RECALL 21V141. 2021-119 REMEDY INSTRUCTIONS

Make(s): Cardinal and Wildcat

Concern: The furnace is not properly secured to the floor allowing movement of the furnace and platform, which could potentially misalign the intake tube and/or exhaust tube. Repair Code: RC-065-01-00-003997

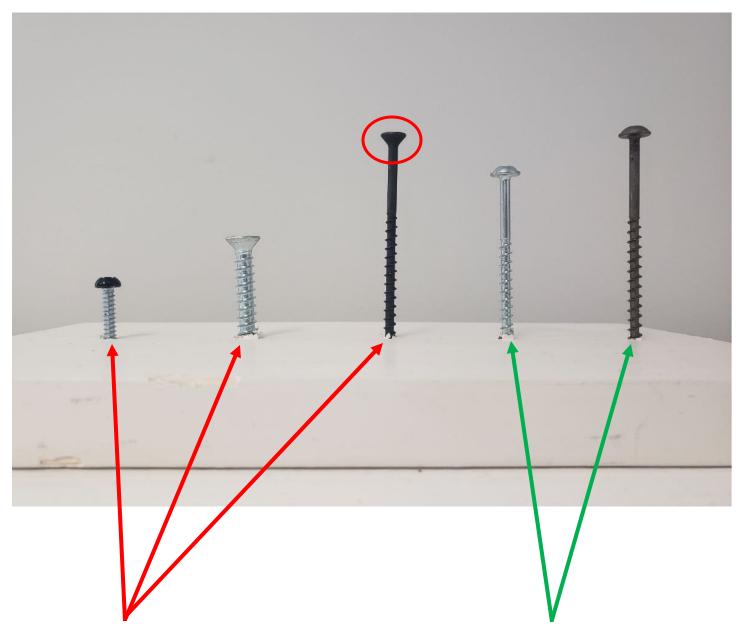
DO NOT USE THESE TYPE OF SCREWS

CORRECT SCREWS: #8 2 1/2" OR #8 3" **COARSE-THREADED WASHER HEAD SCREWS**

3. Install the # 8, 2 ½" or 3" coarse-threaded washer head screws ensuring the screws go through the holes in the bottom of the furnace cabinet, into the platform and into the floor. Figure 4.
